Agenda Item	6.2
Report No	PLS-61-22

HIGHLAND COUNCIL

Committee: South Planning Applications Committee
Date: 18 August 2022
Report Title: 21/02839/FUL: Mr S Entwistle
Land 45M East of Na Sealgairean, Glenfinnan.
Report By: Area Planning Manager – South

Description: Erection of a House.
Ward: 11 – Caol and Mallaig

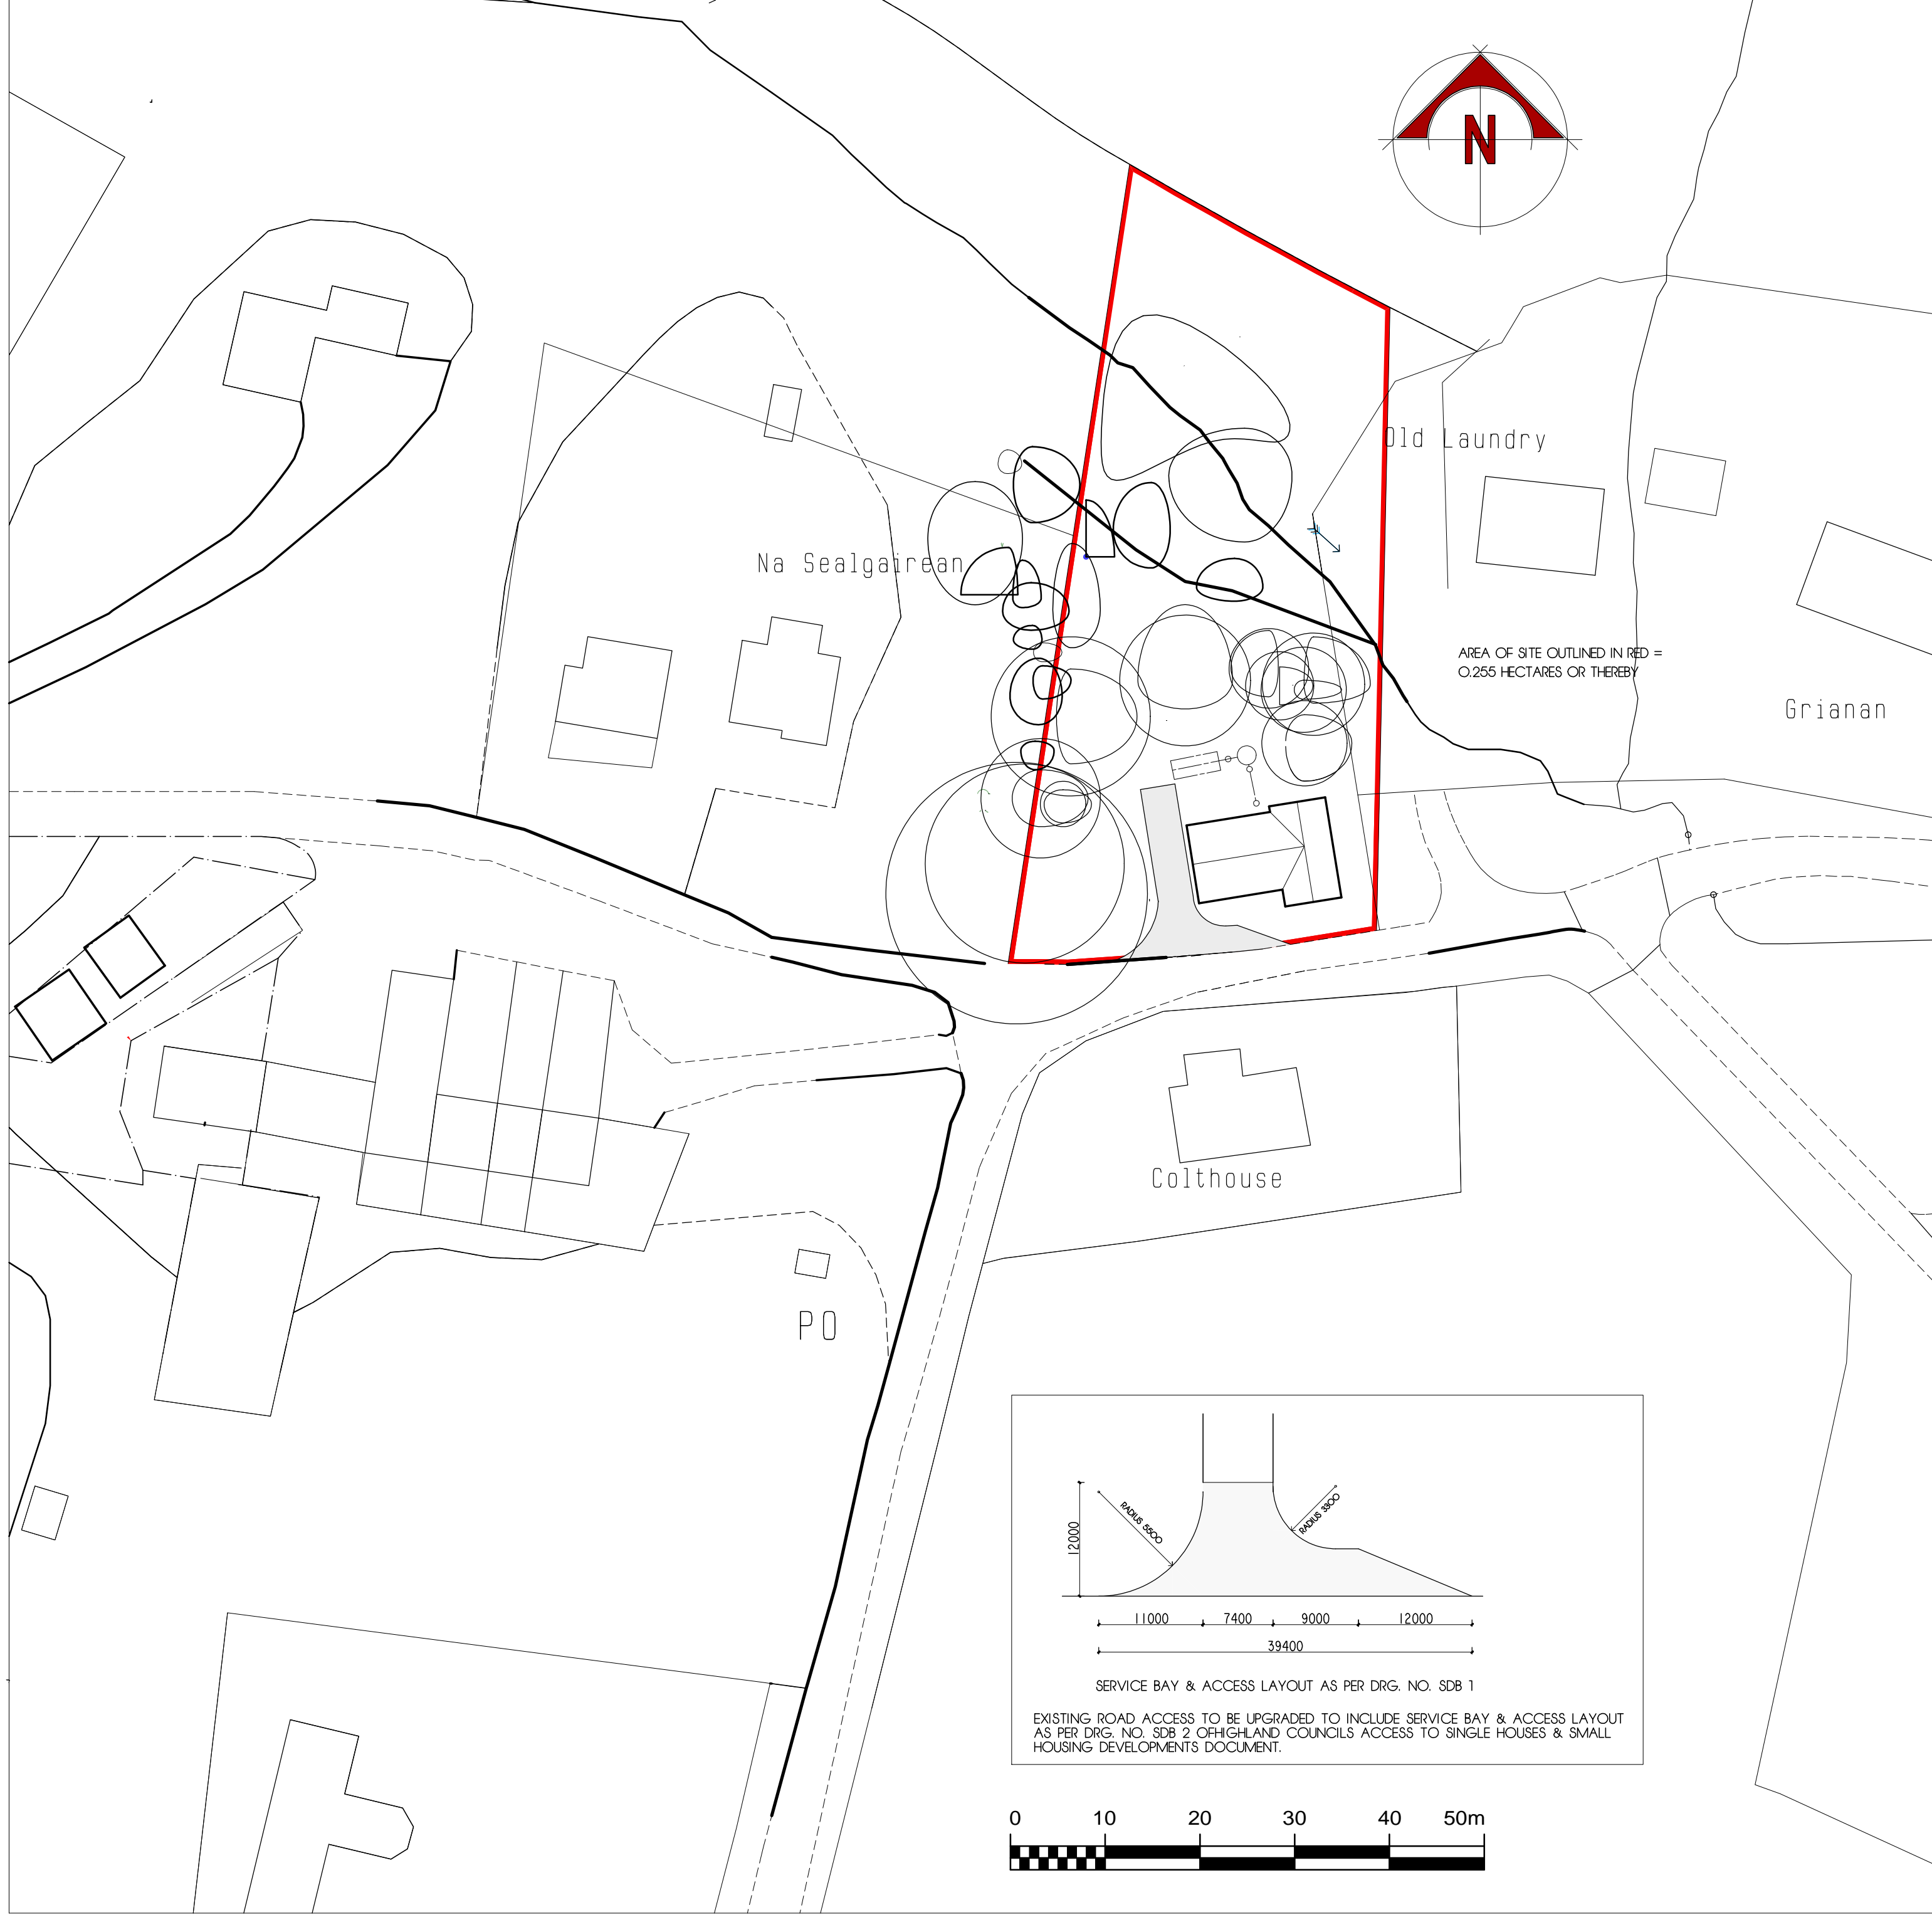
- 1.4 Pre Application Consultation: No pre-application advice given.
- 1.5 Supporting Information: Design Statement; Arboricultural Impact Assessment
- 1.6 Variations: The site layout plan has been amended to include a setback further into the application site to bring the proposed positioning of the house in line with the settlement pattern. A further site plan was submitted which relocated the proposed dwelling back to nearer its original position to the front of the site to allow for less tree removal. The site boundary has also been redrawn slightly to align with the applicant's land ownership which was the subject of a public representation.

- 8.8 Alternative siting for the positioning of a house on this site has been explored, however this has been concentrated to the front of the site where a house in this location would be out of alignment with the neighbouring properties on the north side of the Slatach Road. Although this position reduces further tree losses, it is not considered to respect the existing pattern of development and would still conflict with woodland and natural heritage policies.
- 8.9 The design of the single storey timber clad house with a profiled sheet metal roof is broadly acceptable as properties in Glenfinnan utilise a mix of materials which include both traditional and modern materials. The design and scale is consistent with neighbouring properties.
